Manual Erratum

Manual reference: BCN-A211508-000-C

Manual title: **Safety stop function instruction manual for FR-D700 Transistorized Inverter**

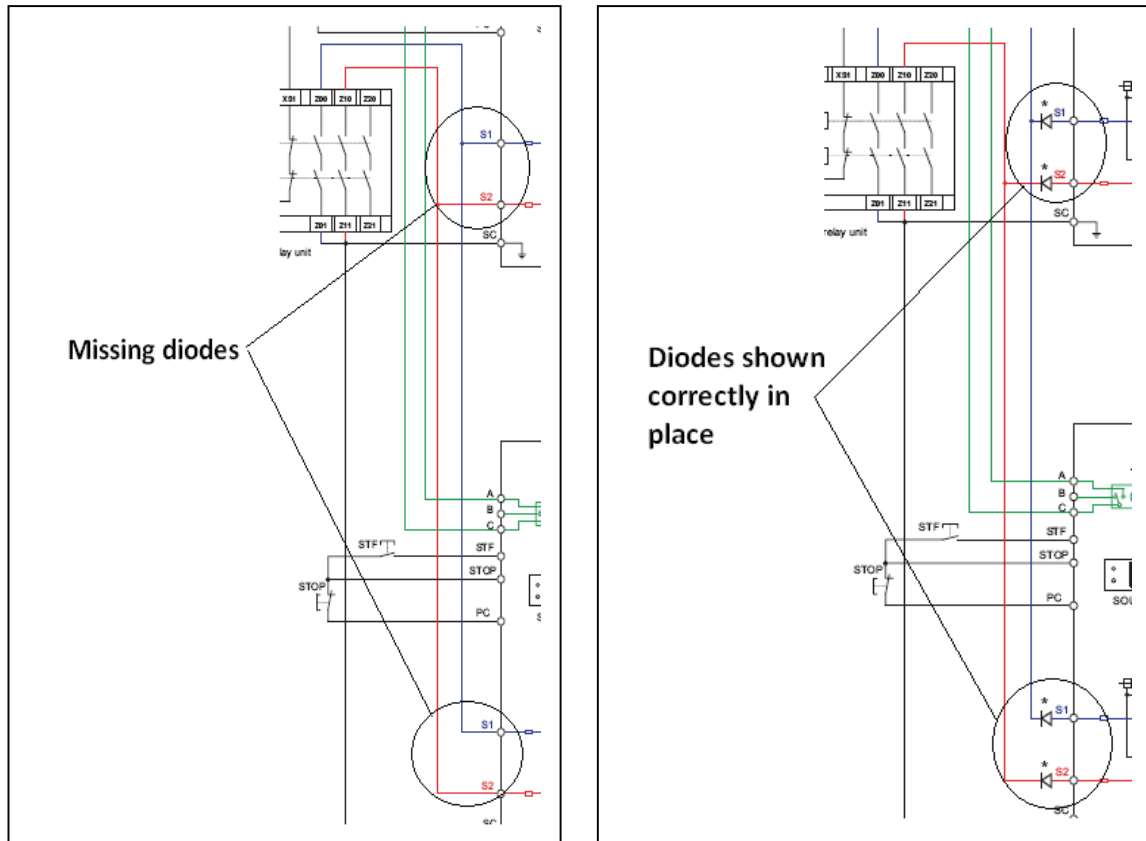
The drawing on page 6 of the manual BCN-A211508-000-C has does not show diodes which must be placed on the inputs S1 and S2 when using a parallel wiring configuration.

Incorrect diagram
(BCN-A211508-000-C)

Correct diagram
(BCN-A211508-000-D)

Without these diodes in place when the user installs a configuration which has multiple FR-D700 inverters with their Safe Torque Off inputs (S1 and S2) wired in parallel to a single safety relay with one or more of the connected inverters powered off, then in this condition there is a strong potential that the Safe Torque Off function will not activate when required on the inverters that remain powered.

Diode specification:

V_r (peak reverse voltage) : 50V or more.

I_f (forward current) : 100mA or more.

V_f (forward voltage) @ 5mA : 1V or less.

Type of diode : PN junction type

A Schottky barrier diode is not appropriate for this application as its reverse leakage current is large.
